**Released Engineering Change Notice**

Product	ZED 1402
---------	----------

Title	Securing of Distribution PCB with Cable Tie
-------	---

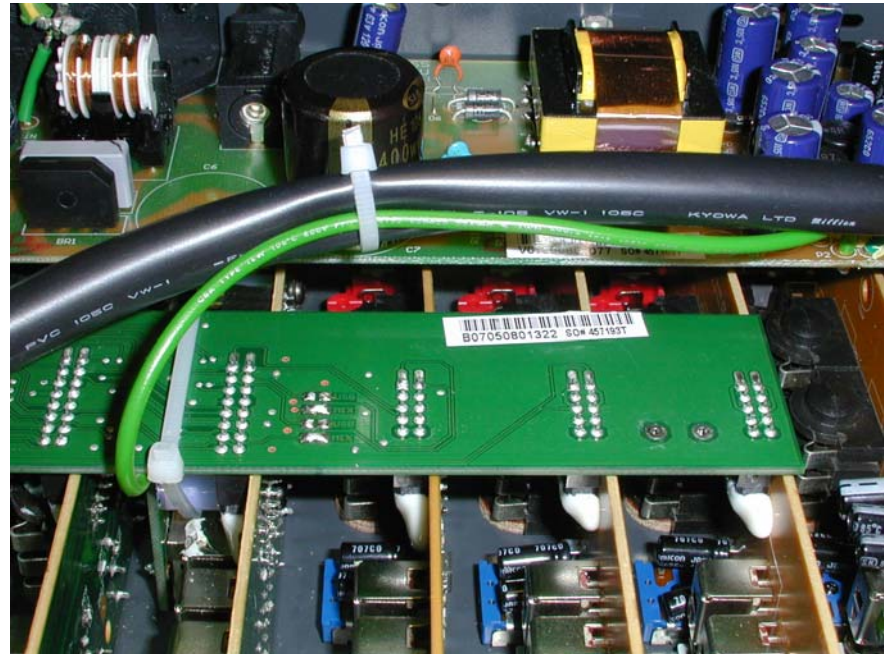
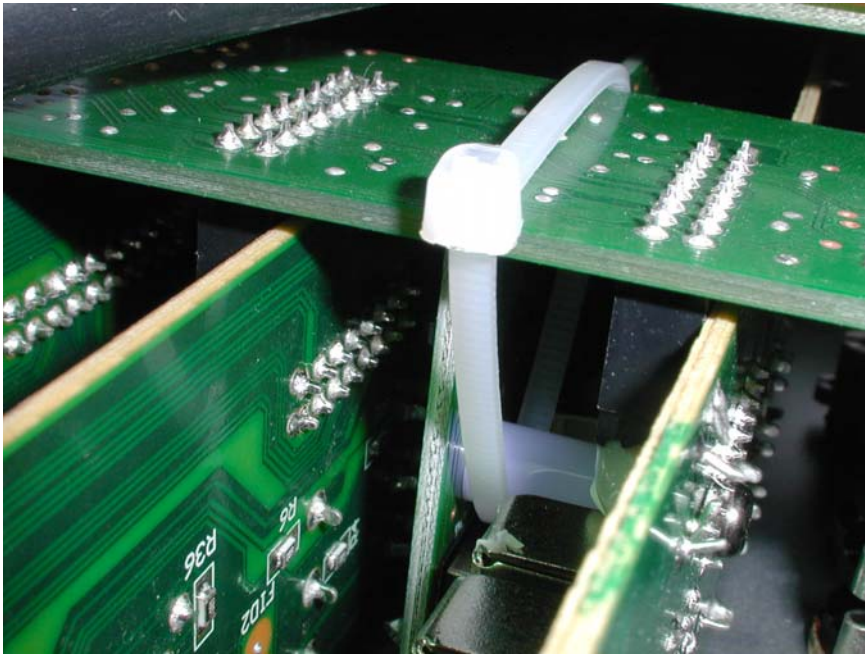
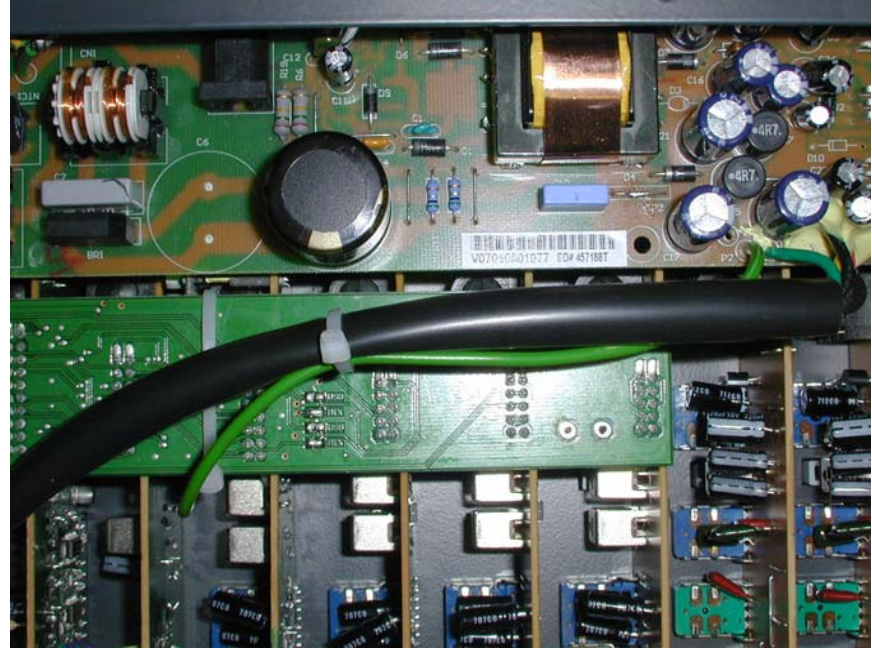
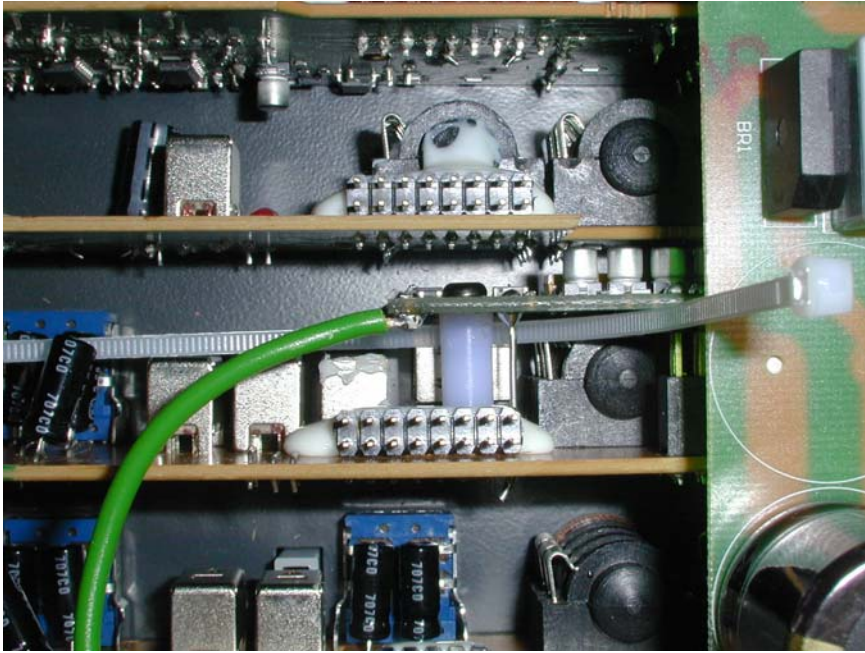
Details Of Change
Add cable tie to secure Distribution

Reason for change
To ensure Distribution pcb does not fall off in transit.

Additional Information
Secure 003-658 PCB ASSY ZED 14 DISTRIBUTION with AK0332 CABLE TIE 2.5X200MM around the pillar mounting the USB to Stereo 13/14. Route the cable tie behind pillar and TC wire. Mount Distribution and secure with cable tie. See attached photos.
